Change Order

PROJECT: (Name and address)
Powell County MS Wall Repair
Powell County, KY

CHANGE ORDER INFORMATION:
Change Order Number: 003
Date: 09-02-2025

CONTRACT INFORMATION:Contract For:
General Construction
Date:
07-30-2025Architect's Project Number: 202452
Proposal Request Number: PR-03

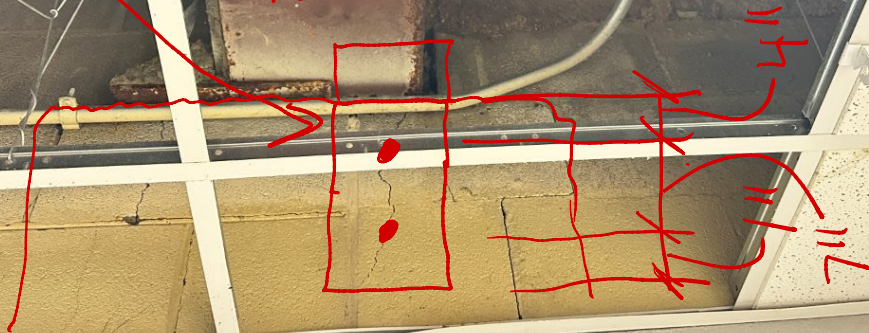
Provide pricing, including labor and materials, to repair the CMU wall above the ceiling at the Science Room 148 per the following sketches. This includes saw cutting holes in the top of the CMU wall and grouting solid the CMU cores in about a 6'-8" width from the inside corner. Provide & install a bent plate below the existing steel beam, next to the existing offcentered bearing plate. The bent plate to be 3/8" thick, 4" long (at beam bearing) x 12" (high) x 6" wide with (2) 1/2" dia. HAS rods (Hilti) set 6" into grouted cells with Hilti HIT-HY 270 Adhesive. Below the existing beam, saw-cut holes into the CMU and grout solid in a 2'-8" wide area, centered on the beam. Note some of these cells might already be grouted.

SAW-CUT HOLES &
GROUT SOLID DOWN
TO FTG.

6' - 8' (\pm)

BENT $\Phi \frac{3}{8} \times 4" \times 12"$
 $\times 6"$ LONG W/ 2 - $\frac{1}{2}" \Phi$
HAS RODS SET 6" INTO
GROUTED CELL W/ HILTI
HIT-HY 270 ADHESIVE

2'-8" (+)

SAW-CUT HOLES &
GROUT SOLID DOWN
TO FTG.
